ERRATA INSERTED
PER LETTER B-31-78 which
TRANS ERRATA.
(CORRECTIONS ARE IN BLACK
RED INK.)

ERRATA LTR DTN 8-31-78...
782480108

INFLUENCE OF INDIAN POINT UNIT 2
AND OTHER STEAM ELECTRIC GENERATING PLANTS
ON THE HUDSON RIVER ESTUARY
WITH EMPHASIS ON STRIPED BASS AND OTHER FISH POPULATIONS

January 1977

Figure 6.2-1 Longitudinal Distribution of Early Life Stages of Striped Bass during 1975 in Hudson River Estuary (RM 14-140; km 23-225) Based on Epibenthic Sled and Tucker Trawl Samples

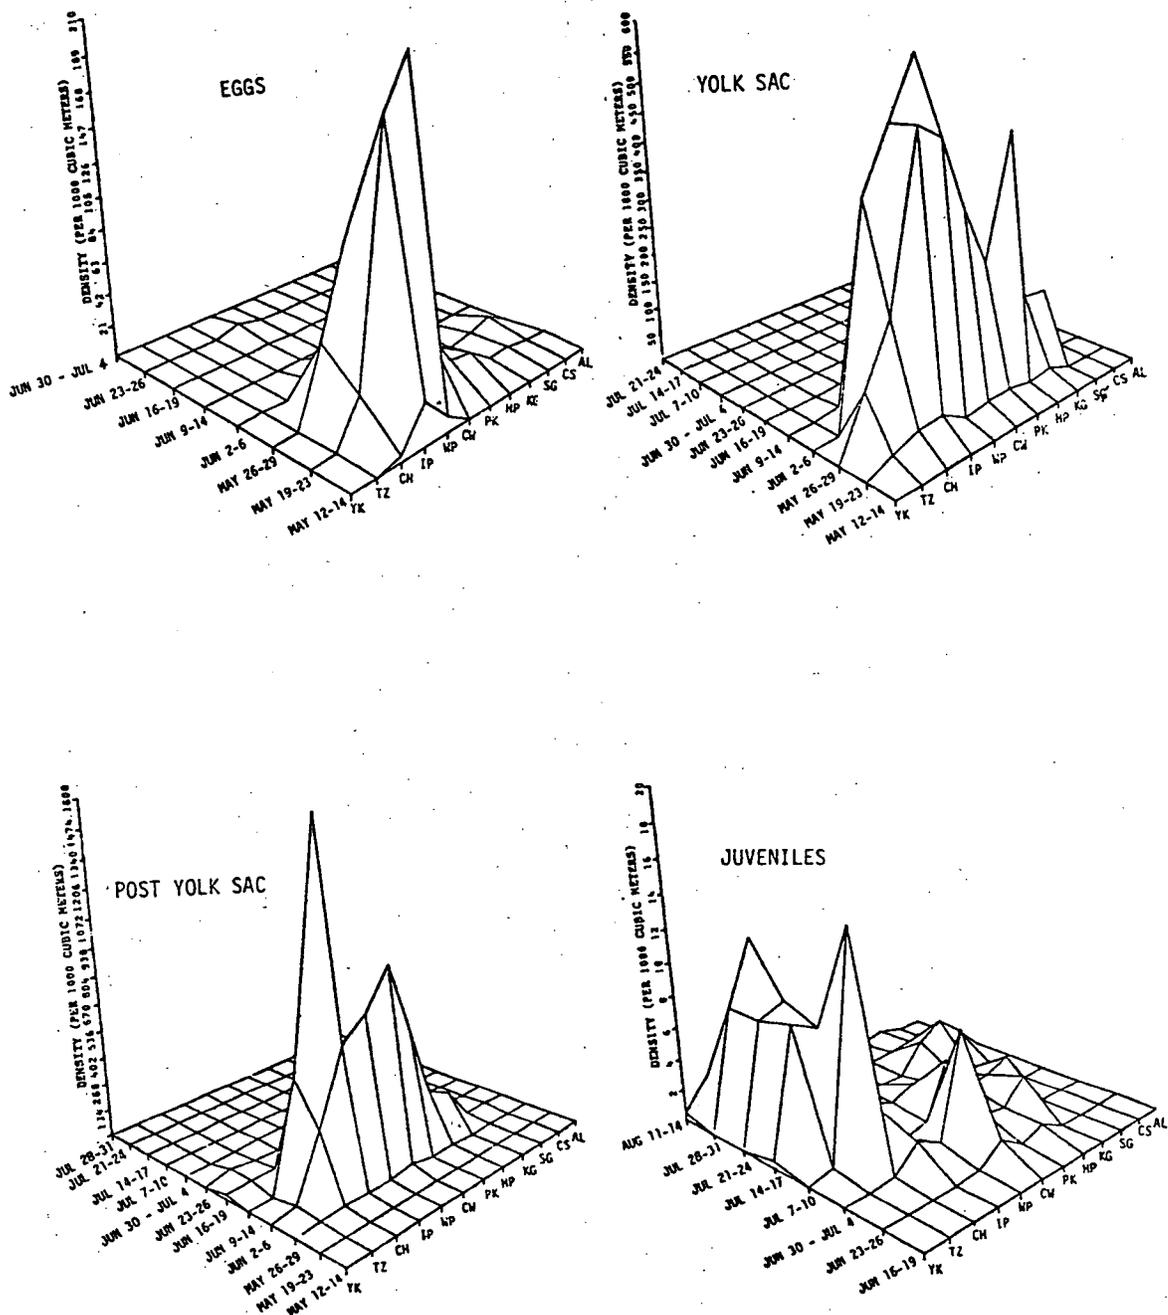
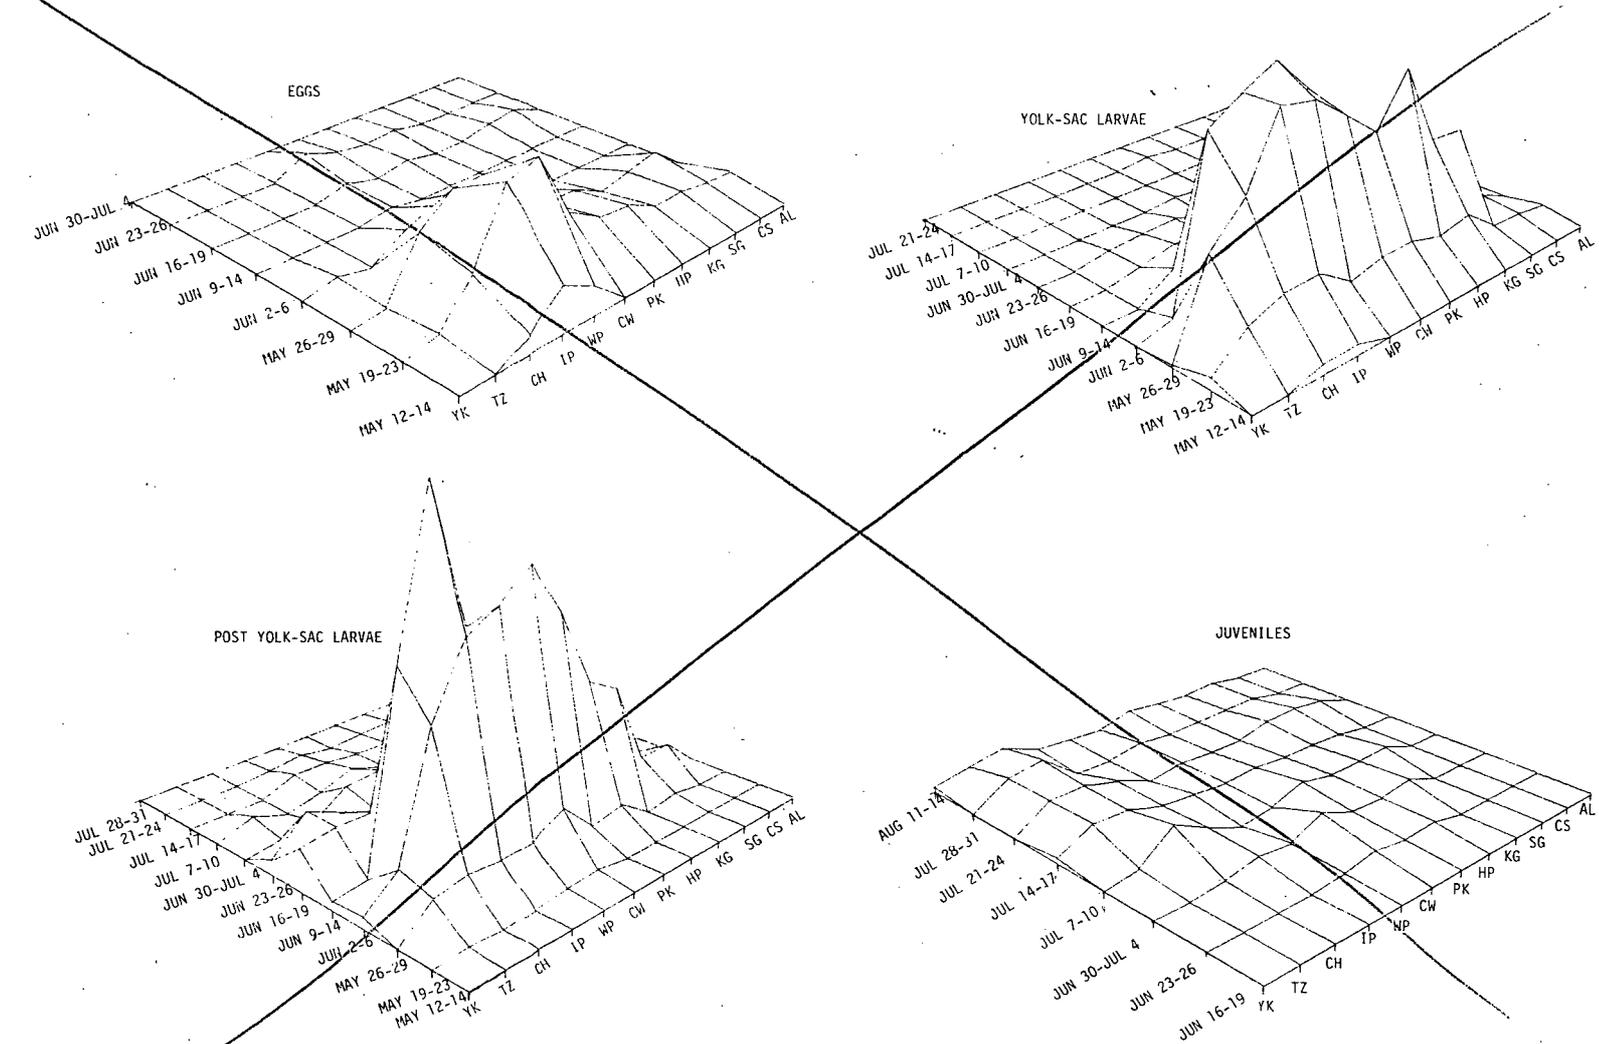
This is a replacement figure.

delete

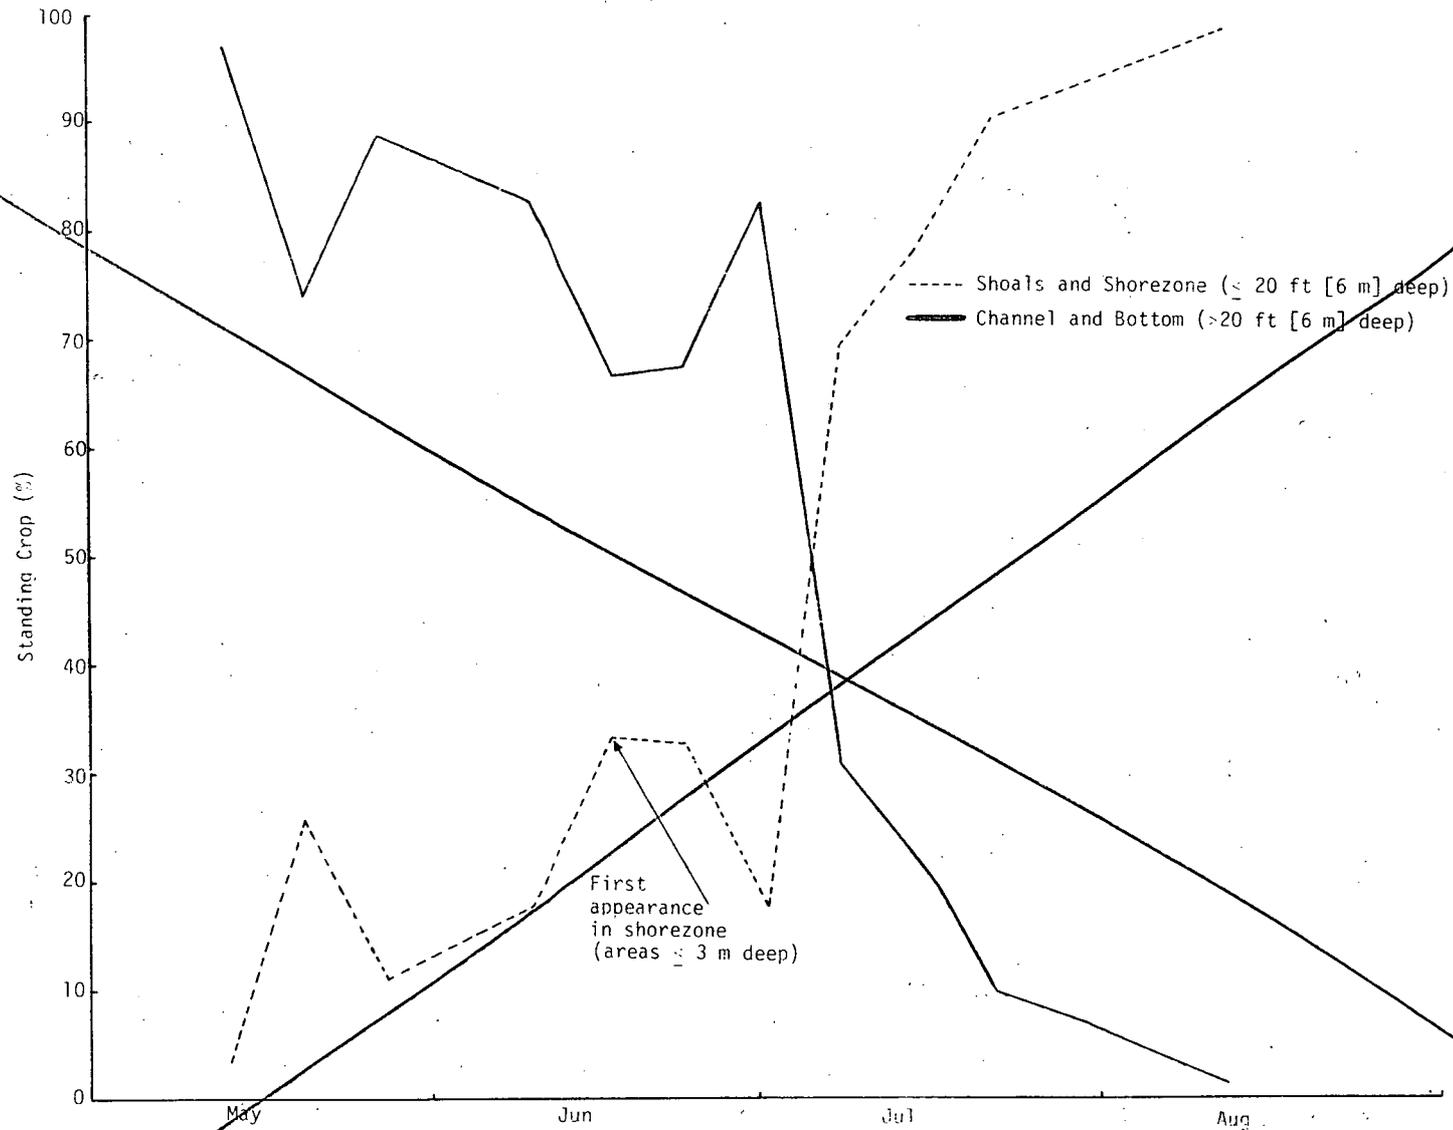
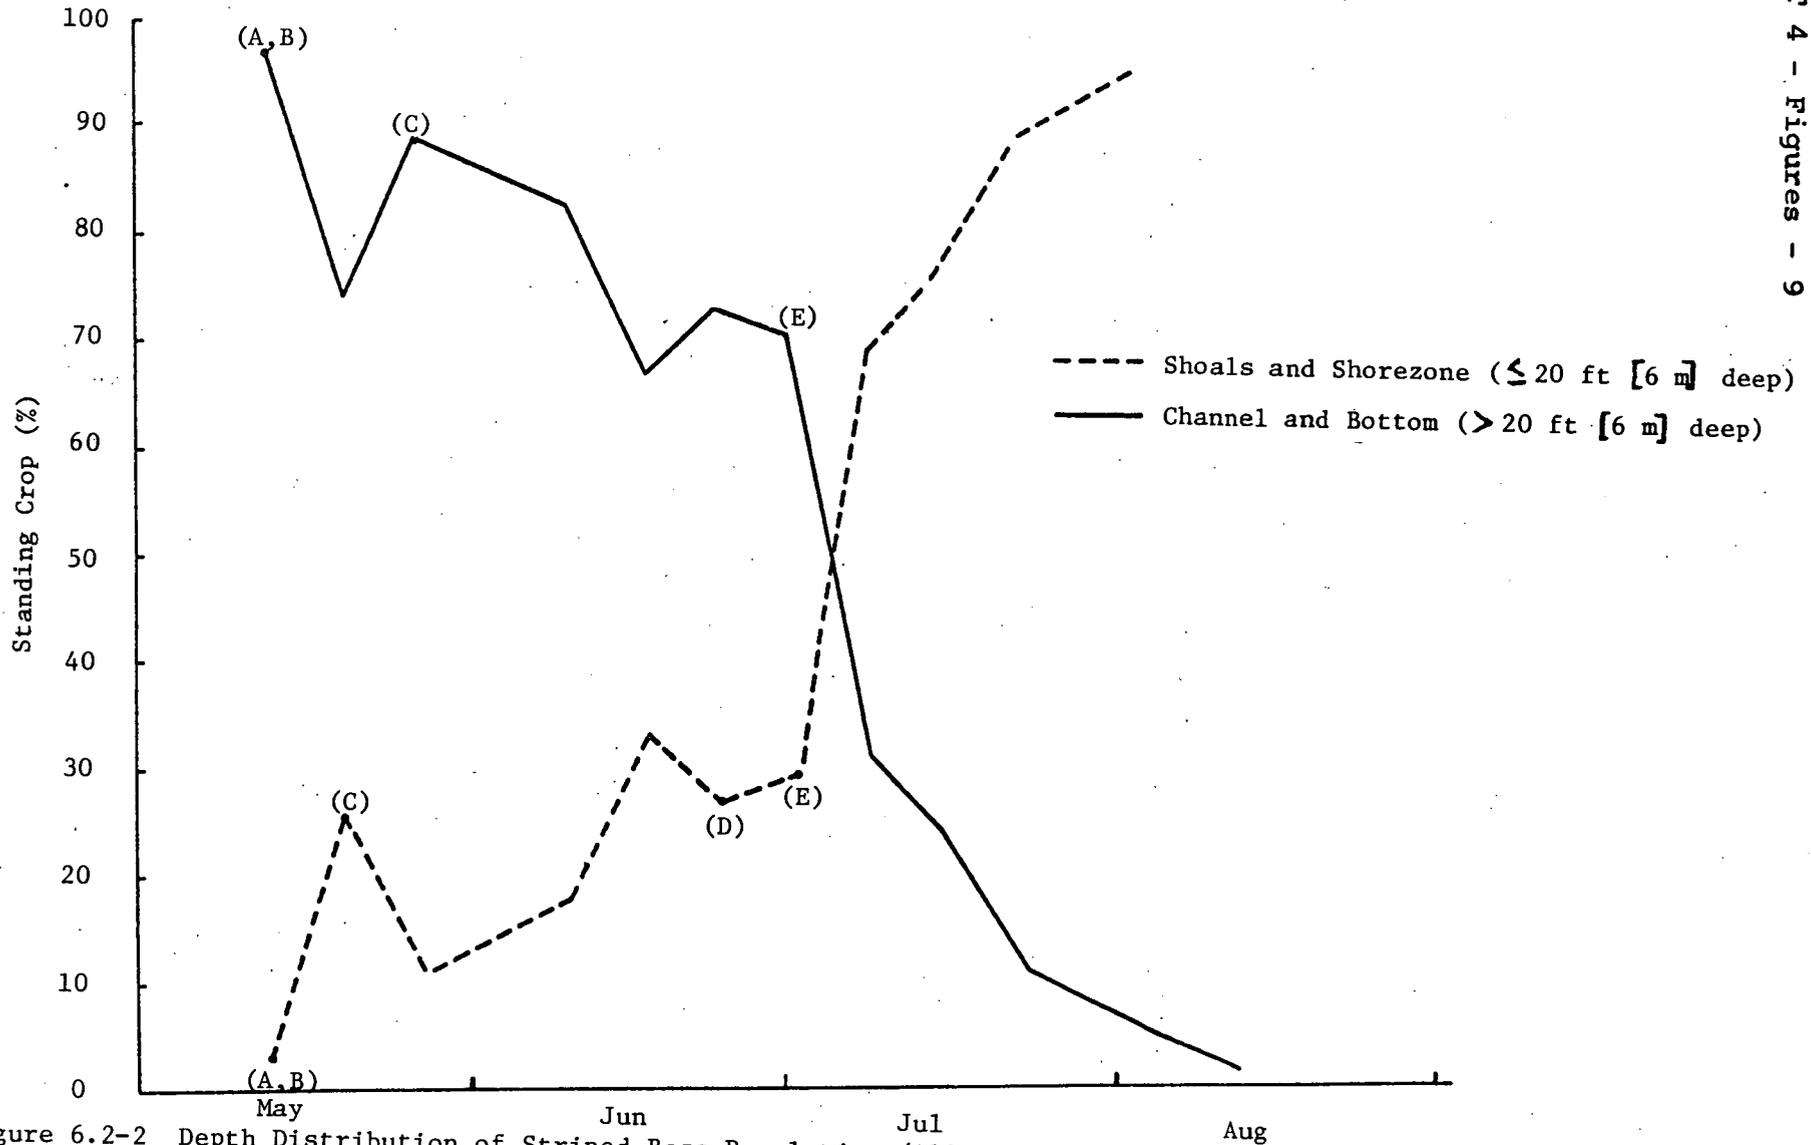
NOTE: This is a replacement figure.

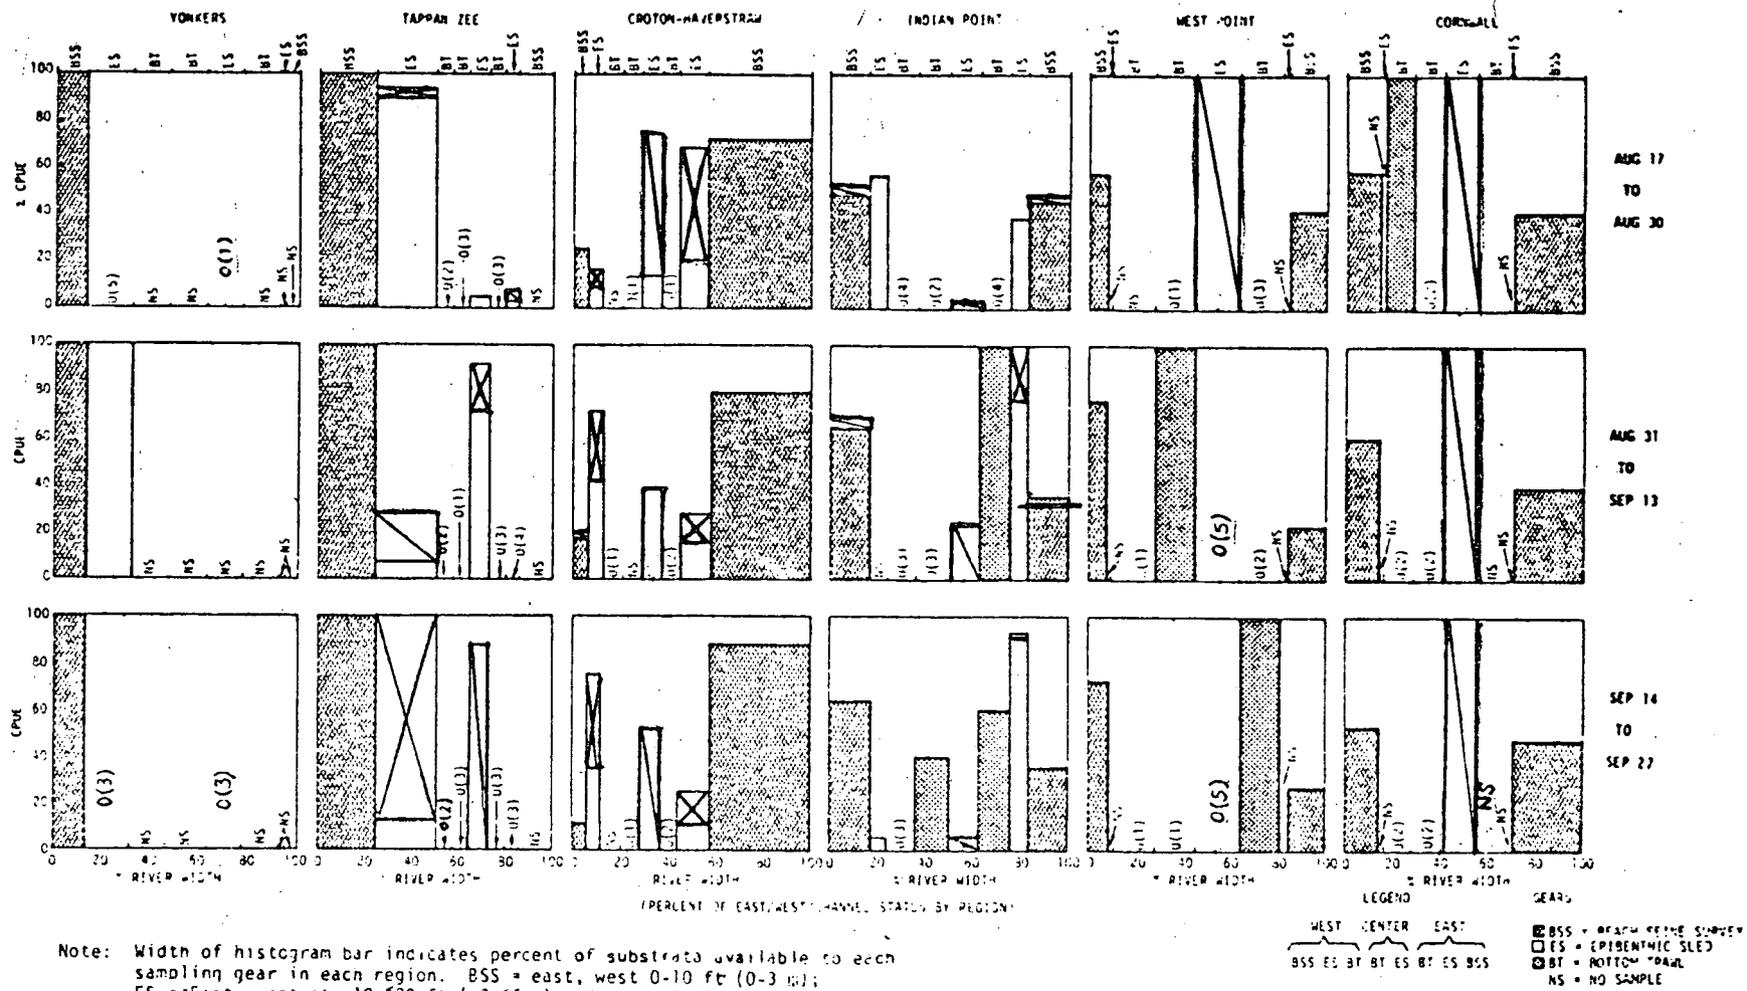
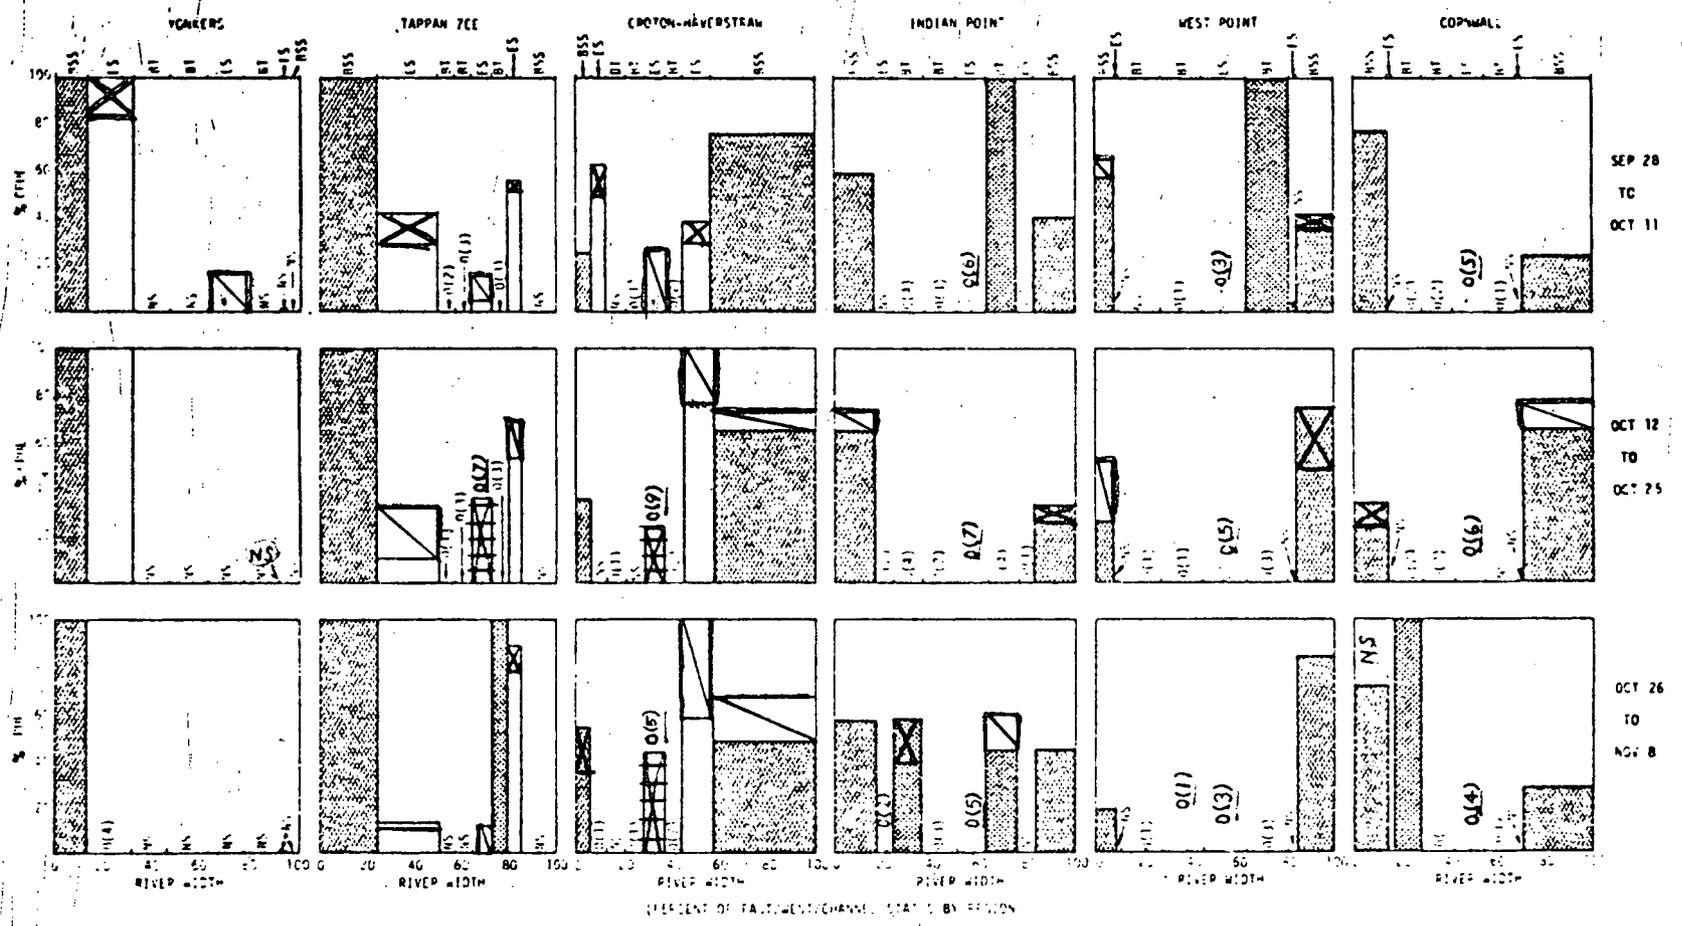
(Changes shown - not a replacement page)
